ADDENDUM NO. 02

Project: Conway Corporation
Roger Q Mills Jr.
Water Treatment Plant 8 MGD Expansion & Improvements

The Contract Documents dated May 3, 2024, are hereby amended as follows:

BASIN FILL UNDERDRAIN
PLAN
SCALE = 1" = 40'

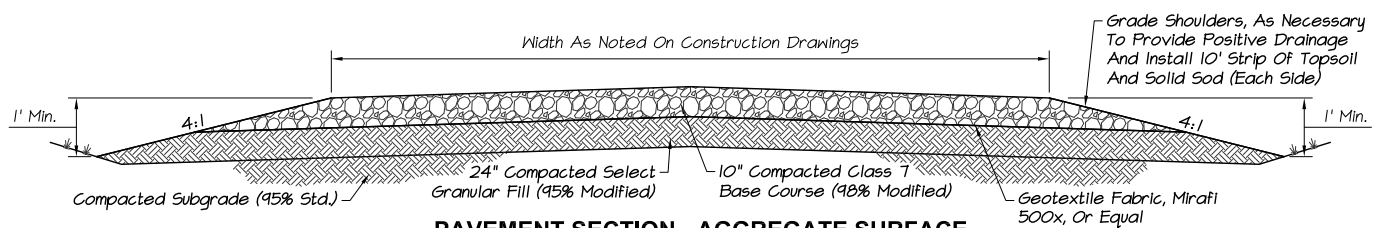
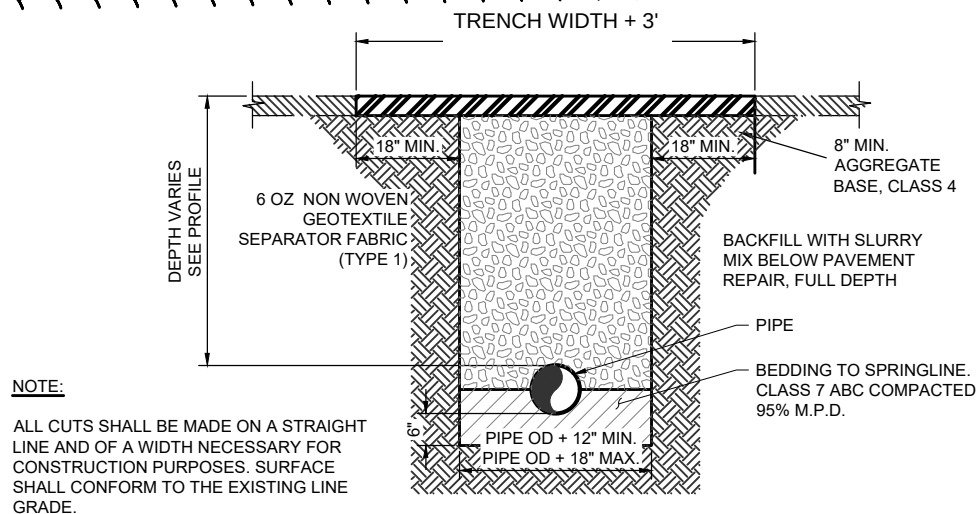
2. Drawing 05-C104 – (Sheet 024):
 - a. Delete the second sentence in Note 16.
3. Drawing No. 05-C105 (Sheet 025)
 - a. Delete the drawing in its entirety and replace it with Basin Underdrain Plan – Addendum No. 02, attached hereto.

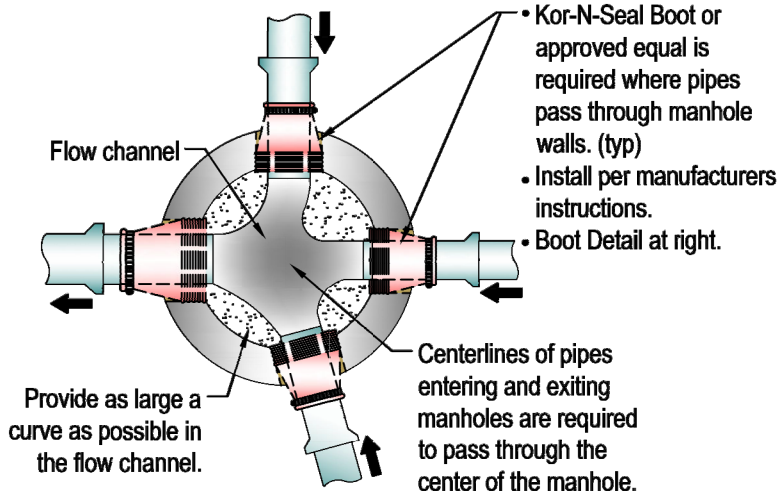
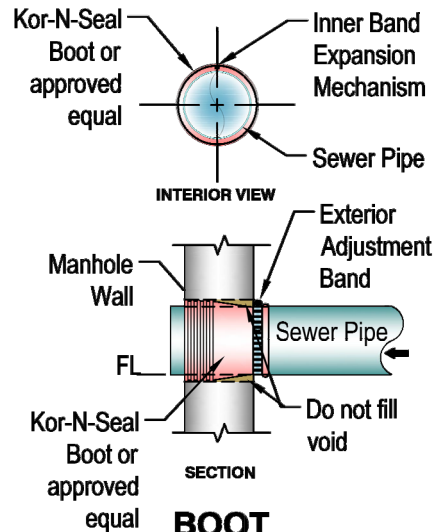
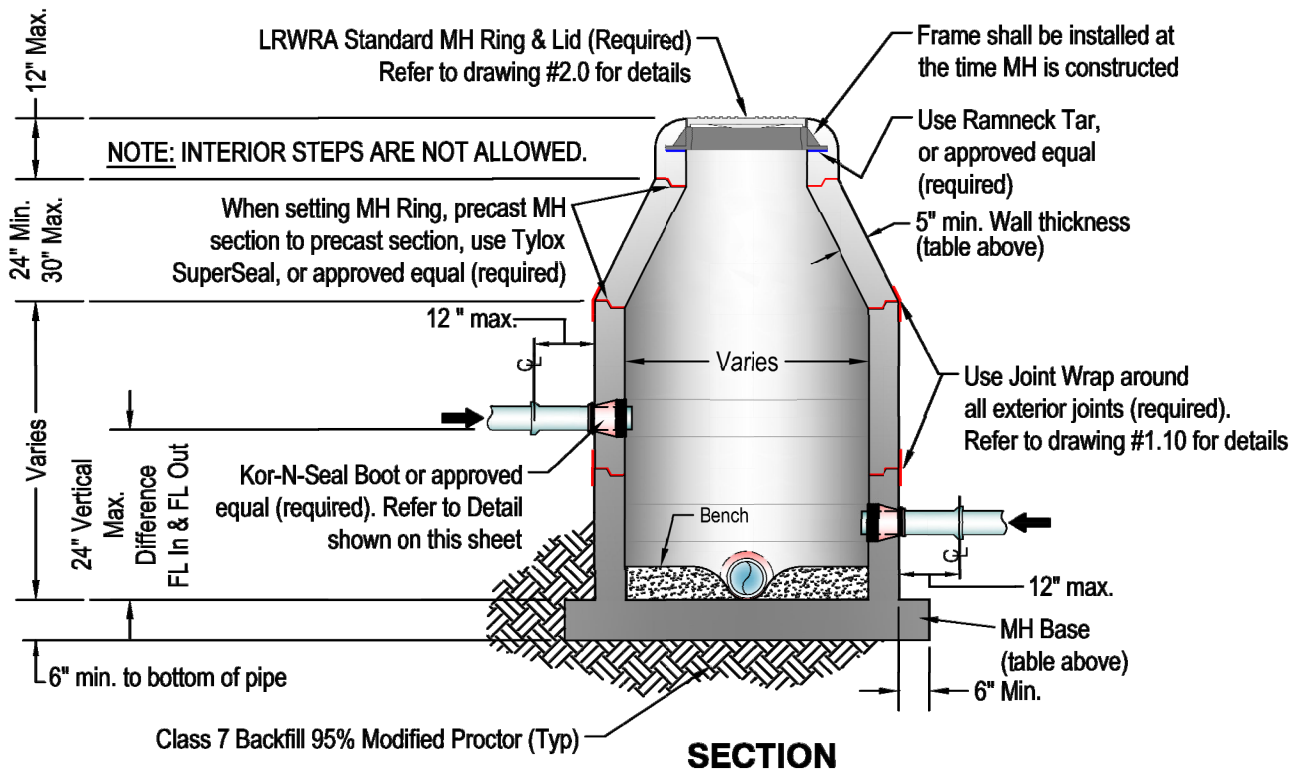
5. Drawing No. 00-CZ105A (New Drawing)
 - a. Add the following drawing Civil Details VII – Addendum No. 02, attached hereto.
6. Drawing No. 00-CZ105 (Sheet 031):

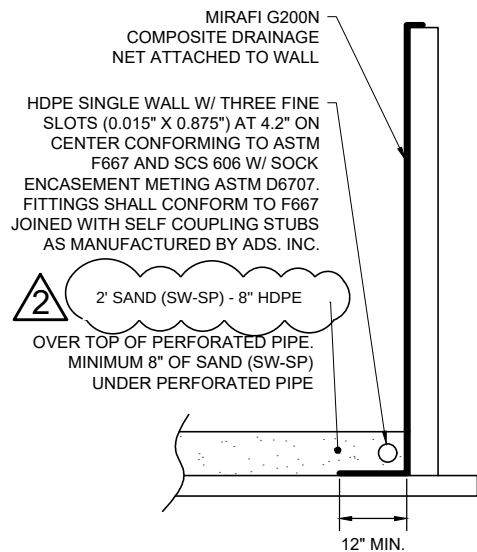
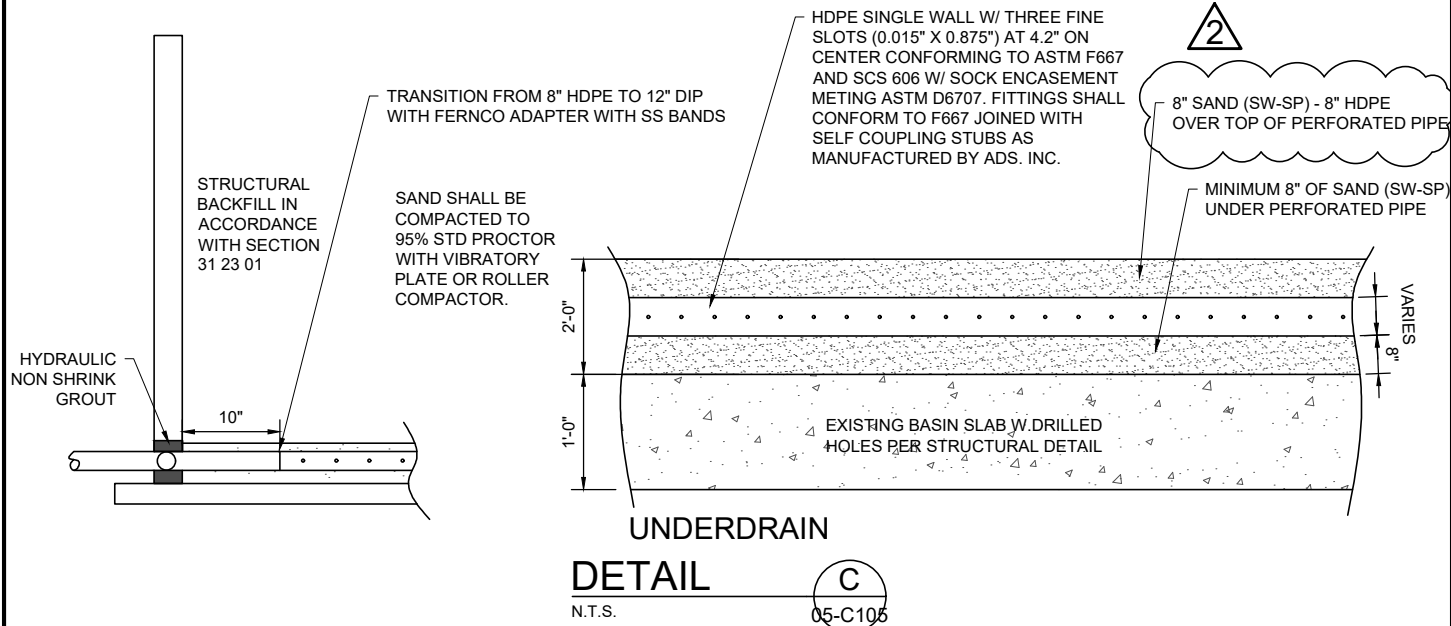
- a. Modify Detail C and Detail E as shown on Civil Details VI – Addendum No. 02, attached hereto.
7. Drawing No. 10-C200 (Sheet 054)
 - a. Modify the Blending Structure Yard Piping shown on the Raw Water Blending Structure Grading Plan and Section – Addendum No. 02, attached hereto.

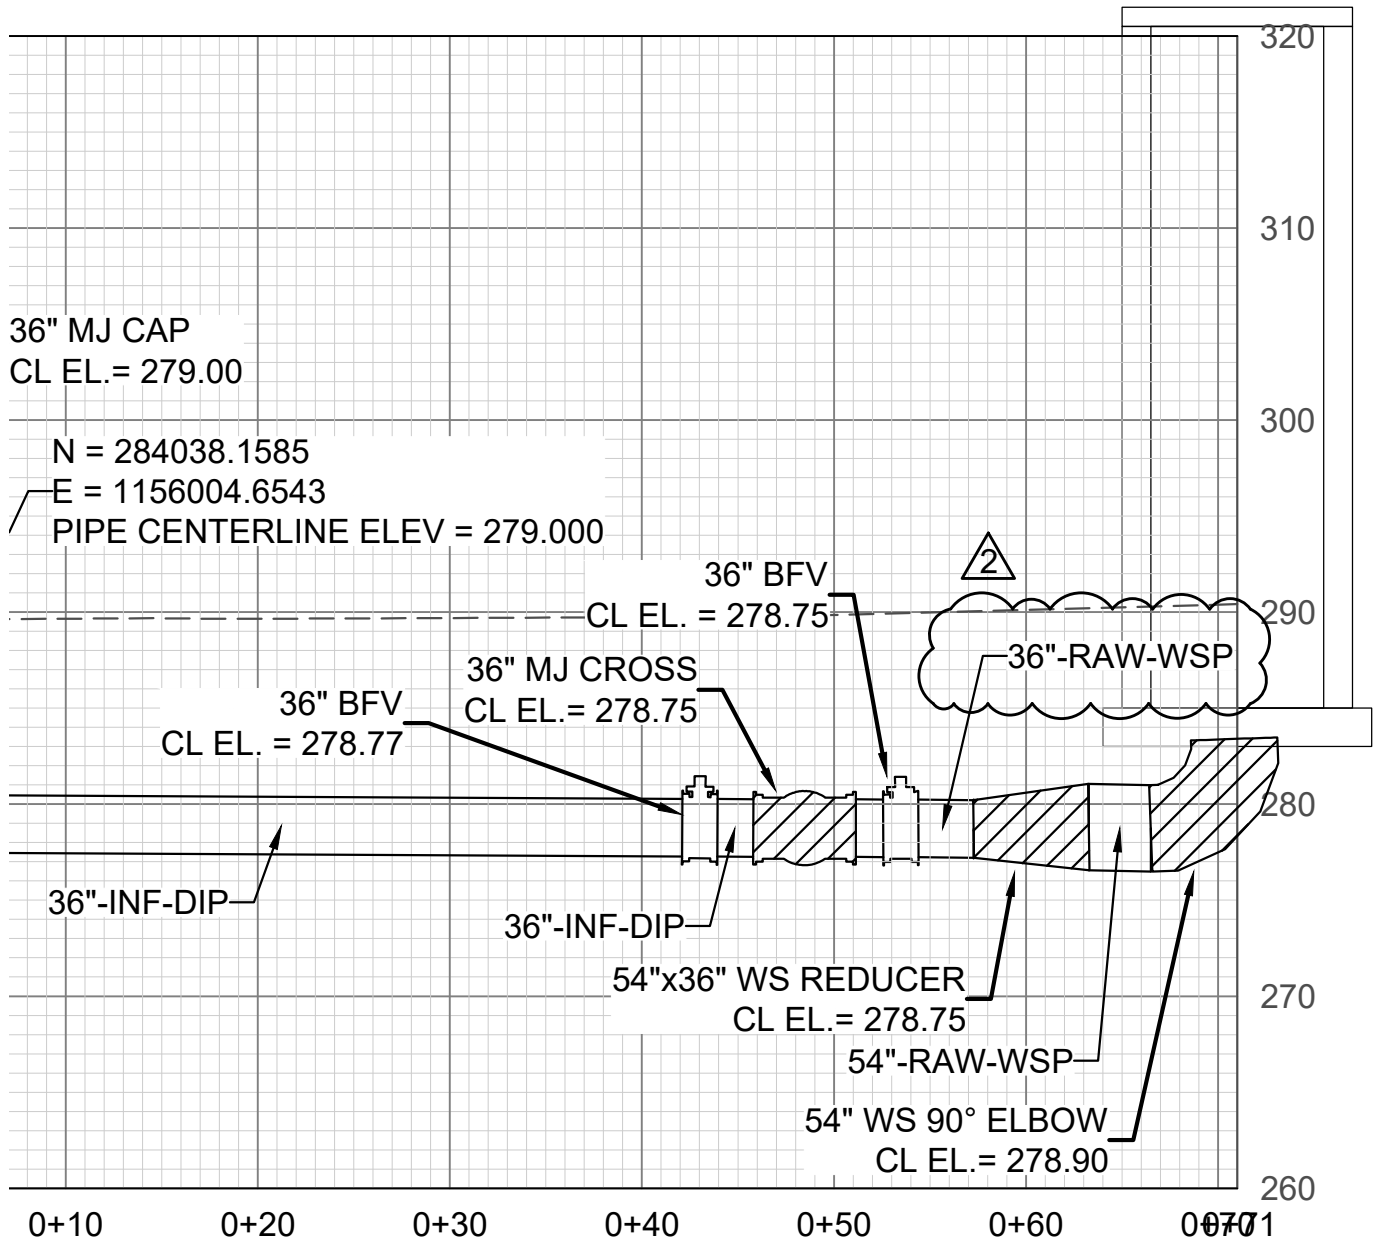
8. Drawing No. 10-C300 (Sheet 057)
 - a. Modify the Profile shown on the Raw Water Blending Structure Plan and Profile 1 – Addendum No. 02, attached hereto.

CEI JOB NO.:
2135
GARVER JOB NO.:
19W01300
DRAWING NUMBER
08-I722
SHEET
NUMBER **050**

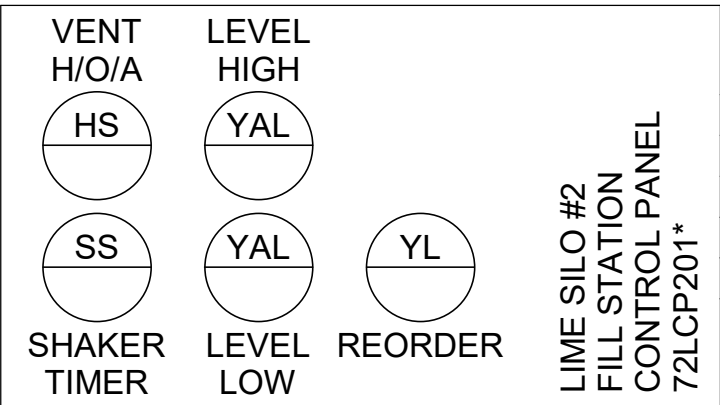
9. Drawing No. 08-I722 (Sheet No. 050)
 - a. Delete the entire drawing and replace it with Drawing No. 08-I722 - LIME SILO AND MIXING TANK 2 P&ID - Addendum No. 02, attached hereto.
